From: Kitchen, Robert [robert.kitchen@pgnmail.com]
Sent: Monday, July 02, 2012 9:30 AM
To: Habib, Donald
Subject: DRAFT - Revised FSAR 2.5.4 Text and Figures
Attachments: FSAR Section 2.5.4 Text and Figure Revisions - Grouting.pdf

Don – Attached are DRAFT changes planned to FSAR 2.5.4 text and figures. These changes are to clarify some content and do not change the planned approach for foundation design. Also, these changes are not related to the seismic RAI. I will send draft response to seismic RAI later today.

Progress Energy Florida
Levy Nuclear Plant
Units 1 and 2
Part 2, Final Safety Analysis Report
LNP 1 Nuclear Island Excavation Limits
Plant South To Plant North Cross Section

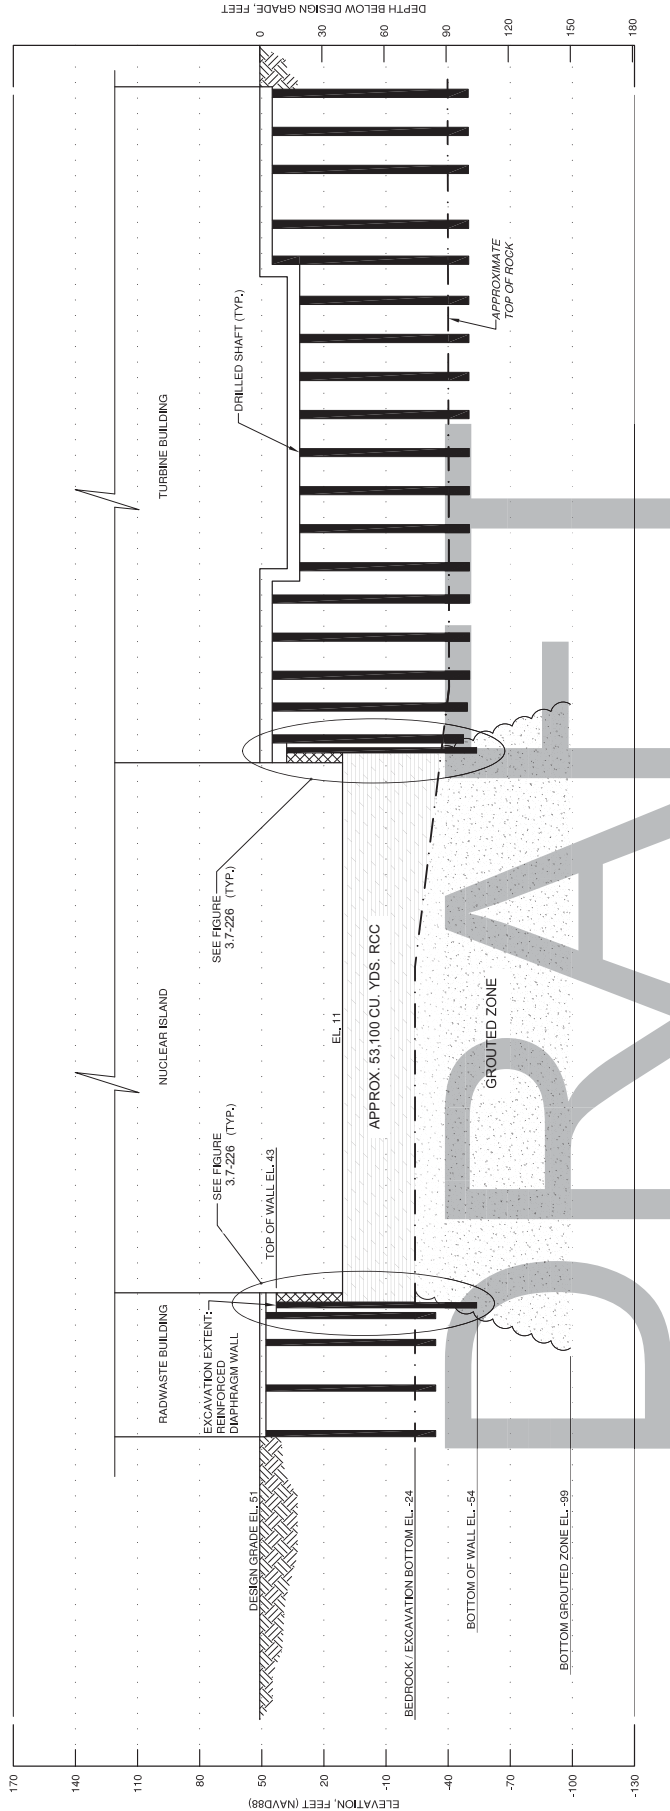
Deleted: The Grout Program will be accomplished in two phases. Prior to the excavation of the nuclear island foundations, grout holes will be drilled from the existing ground surface to the proposed bottom of the target grouted zone (approximately 150 ft bgs). The first phase will consist of drilling and grouting on 8-ft. center-to-center spacing with a relatively low mobility grout (LMG). This LMG helps to form a perimeter to contain the second phase of grouting. The LMG grouting includes the installation of the grout curtain below the diaphragm wall. The purpose of the grout curtain is to "extend" the diaphragm wall and form a border around the grouted zone. A high mobility grout (HMG) will be drilled and grouted on split-spacing between the LMG holes. The HMG will fill in the area defined by the LMG. This is considered the second phase of the Grout Program. ¶¶

¶ State-of-the-practice computerized monitoring of all grouting will take place, including the measurement of grout take in terms of pressure and volume. A field test will be conducted prior to construction of this grouted zone to establish appropriate mixes for both the LMG and HMG and to confirm that the grout hole spacing is adequate. The 8-ft. grout hole spacing is currently based on experience in the industry. It is noted as a good starting point to be refined with a field test prior to and during construction.¶¶

Deleted: The grouting operation will be conducted from, at or near, the existing ground surface by drilling boreholes from the surface down to the approximate elevation of -30.2 m (-99 ft.) NAVD88, and setting casing (either perforated or “tube-a-manchette” – a rubber sleeve between two packers). While uncased holes would be preferred, the existing site characterization data suggest that the holes may cave before they can be grouted; therefore, casing will be specified. The top elevation of the grouted zone will be at elevation -7.3 m (-24 ft.) NAVD88, resulting in a 22.9 m (75 ft.) thick grouted zone.¶

¶ Grouting will generally be performed by the upstage method with pneumatic packers and a combination of lower mobility grout (LMG) and high mobility grout (HMG) to be established with a Grout Test Program prior to the commencement of the grouting program, as discussed in FSAR Subsection 2.5.4.5.1.2.2. Grout holes are initially spaced to achieve “no take” conditions. Hole spacing, grouting pressures, and acceptable grout takes will be established with the Grout Test Program. Grouting is non safety-related, however it will be performed under a quality program.¶

¶ A grout intensity number (GIN) curve and target permeability (in Lugeons) will be used to dictate target grout pressures/volumes. The grout holes will be installed using an automated real-time monitoring system for water pressure testing and grouting, capable of computing a suite of engineering data allowing side-by-side evaluation of geology, grout mixes, Lugeon values and apparent Lugeon values, and plotting data into reports and CADD drawings.

2.5.4.5.1.2.1 Permeation Grouting Operation

The grouting operation will be conducted from, at or near, the existing ground surface by drilling boreholes from the surface down to the approximate elevation of -30.2 m (-99 ft.) NAVD88. The top elevation of the grouted zone will be at elevation -7.3 m (-24 ft.) NAVD88, resulting in a 22.9 m (75 ft.) thick grouted zone.

Grouting will generally be performed by the upstage method with pneumatic packers and a suite of grout mixes that range in viscosities from 35 seconds to over 80 seconds. Primary grout holes will be spaced on a 4.8 m (16 ft.) hexagonal pattern, and split spaced with secondary grout holes to achieve “no take” conditions.

Provisions will be in place to perform additional split-spacing to tertiary grout holes, as dictated by the performance of the production grouting. Effective grouting pressures will be limited to approximately 0.5 psi/ft of depth, monitored using a GIN curve and penetrability curve developed during the Grout Test Program (discussed in FSAR Subsection 2.5.4.5.1.2.2). Hole spacing, grouting pressures, and acceptable grout takes will be established with the grout program. The target residual conductivity of the production grouting will be 15 Lugeons. Grouting is nonsafety-related, however it will be performed under a quality program.
